## **ERRATA FOR EDITION 3**

## PLEASE SEND ANY OTHER ERRATA TO res@ece.ubc.ca.

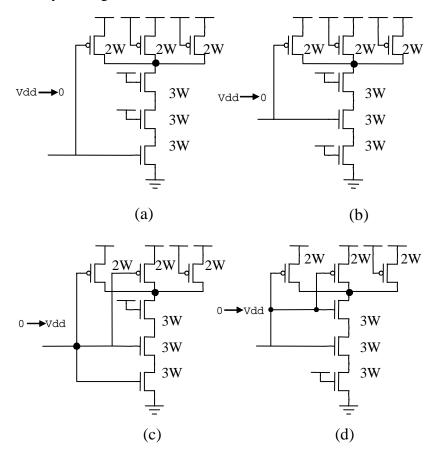
33. p. 304, for clarity, the figures in P6.4 should be shown as follows:

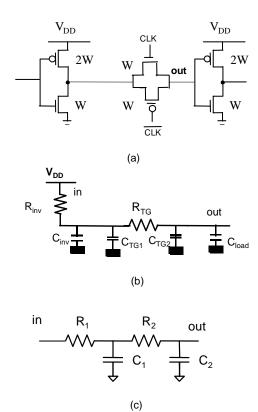
34. p. 307, replace " $LE_R$ " with "rising  $LE_R$ ", and also replace " $LE_F$ " with "falling  $LE_F$ ". Furthermore, Figure P6.10 should have the label F removed from the output of the schematic. This is confusing for the reader due to the use of  $LE_F$ .

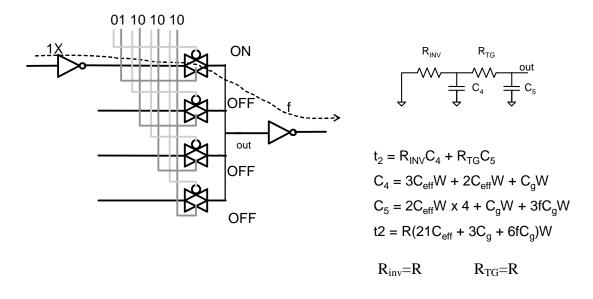
35. p. 329, Figure 7.18(a) should have a label "Out" as shown below:
